**Economic and Social Council**Distr.: General
20 August 2020

Economic Commission for Europe**Inland Transport Committee****World Forum for Harmonization of Vehicle Regulations****182nd session**

1958 Agreement:**Consideration of draft amendments to existing****UN Regulations submitted by GRSP****Proposal for the 04 series of amendments to UN Regulation
No. 94 (Frontal collision protection)****Submitted by the Working Party on Passive Safety ***

The text reproduced below was adopted by the Working Party on Passive Safety (GRSP) at its sixty-fifth session (ECE/TRANS/WP.29/GRSP/67, para. 17). It is based on ECE/TRANS/WP.29/GRSP/2020/4 as amended by Annex VI to the report. It is submitted to the World Forum for Harmonization of Vehicle Regulations (WP.29) and to the Administrative Committee (AC.1) for consideration at their November 2020 sessions.

Model A

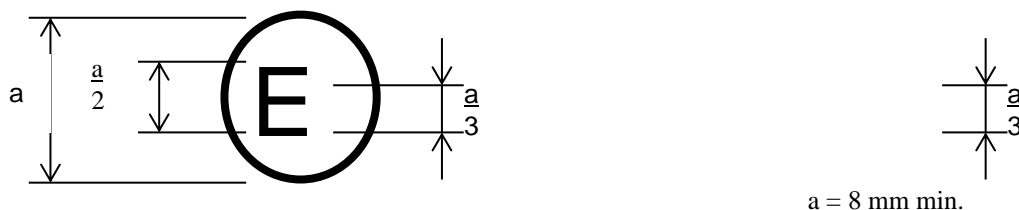
The above approval mark affixed to a vehicle shows that the vehicle type concerned has, with regard to the protection of the occupants in the event of a frontal collision, been approved in the Netherlands (E 4) pursuant to UN Regulation No. 94 under approval number 041424. The approval number indicates that the approval was granted in accordance with the requirements of UN Regulation No. 94 as amended by the 04 series of amendments.

Model B

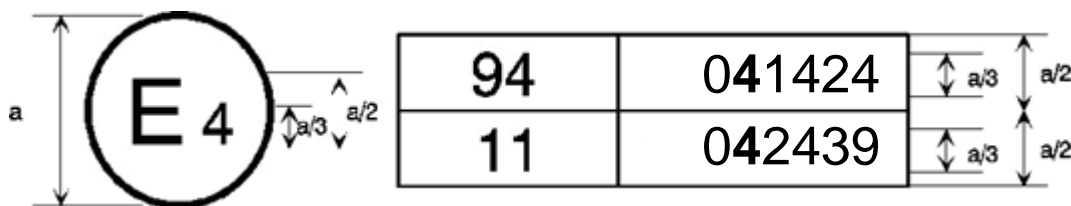
The first two digits of the approval numbers indicate that, at the dates when the respective approvals were granted, UN Regulation No. 94 incorporated the 04 series of amendments and UN Regulation No. 11 incorporated the 04 series of amendments."

Figure 3
Jointed Test Finger

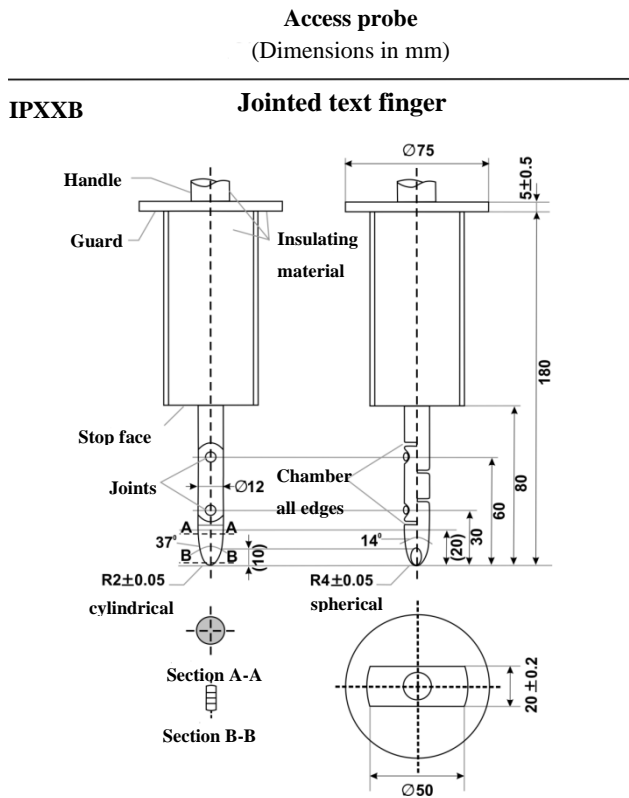
The jointed test finger described in Figure 3 shall be inserted into any gaps or openings of the physical protection with a test force of $10 \text{ N} \pm 10$ per cent for electrical safety assessment. If partial or full penetration into the physical protection by the jointed test finger occurs, the jointed test finger shall be placed in every position as specified below.

Starting from the straight position, both joints of the test finger shall be rotated progressively through an angle of up to 90 degrees with respect to the axis of the adjoining section of the finger and shall be placed in every possible position.

Both joints shall permit movement in the same plane and the same direction through an angle of 90° with a 0 to +10° tolerance.

The requirements of paragraph 5.2.8.1.3. of this Regulation are met if the jointed test finger described in Figure 3, is unable to contact high voltage live parts.

Figure 4

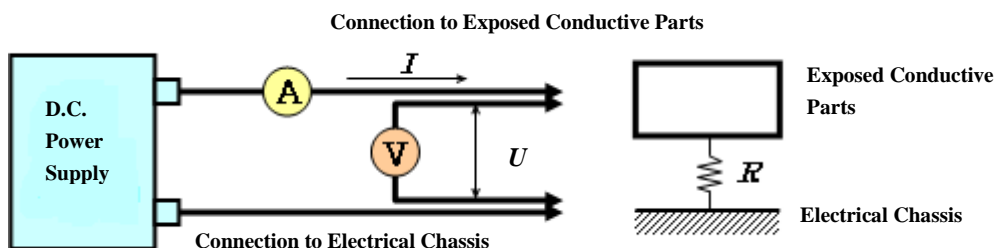
The DC power supply, voltmeter and ammeter are connected to the measuring points (Typically, electrical chassis and electro conductive enclosure/electrical protection barrier).

The voltage of the DC power supply is adjusted so that the current flow becomes at least 0.2 A.

The current "I" and the voltage "U" are measured.

The resistance "R" is calculated according to the following formula:

The resistance R shall be less than 0.1 Ω .

Figure 5

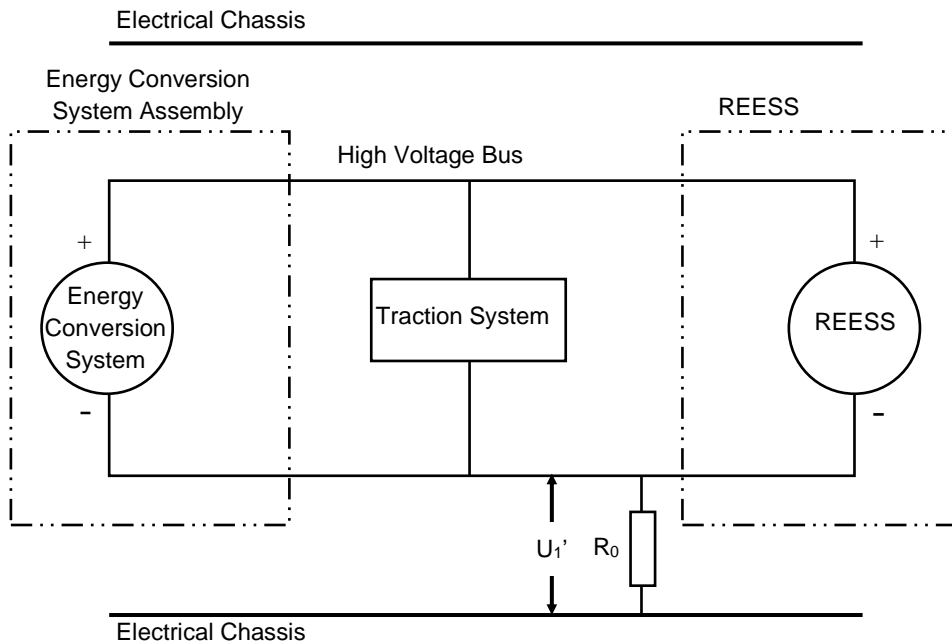
If U_1 is greater than or equal to U_2 , a standard known resistance (R_o) is inserted between the negative side of the high voltage bus and the electrical chassis. With R_o installed, the voltage (U_1') between the negative side of the high voltage bus and the electrical chassis is measured (see Figure 5).

The electrical isolation (R_i) is calculated according to the following formula:

$$R_i = R_o * U_b * (1/U_1' - 1/U_1)$$

Figure 6
Measurement of U_2'

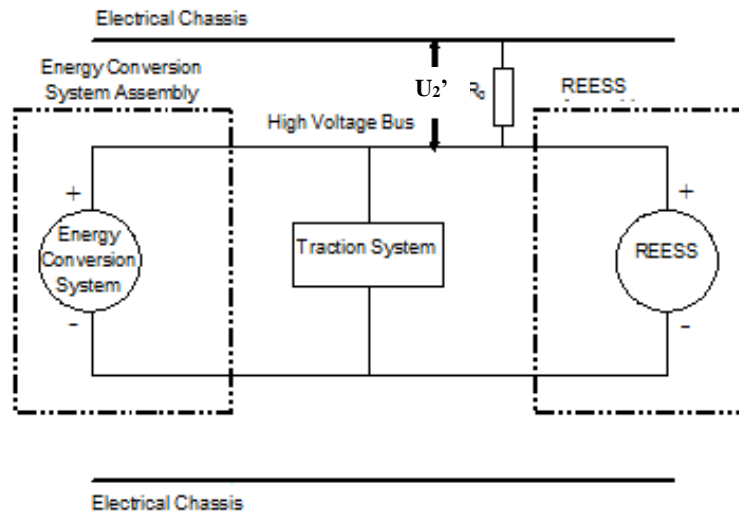
If U_2 is greater than U_1 , insert a standard known resistance (R_o) between the positive side of the high voltage bus and the electrical chassis. With R_o installed, measure the voltage (U_2') between the positive side of the high voltage bus and the electrical chassis (see Figure 6 below). The electrical isolation (R_i) is calculated according to the following formula:

$$R_i = R_o * U_b * (1/U_2' - 1/U_2)$$
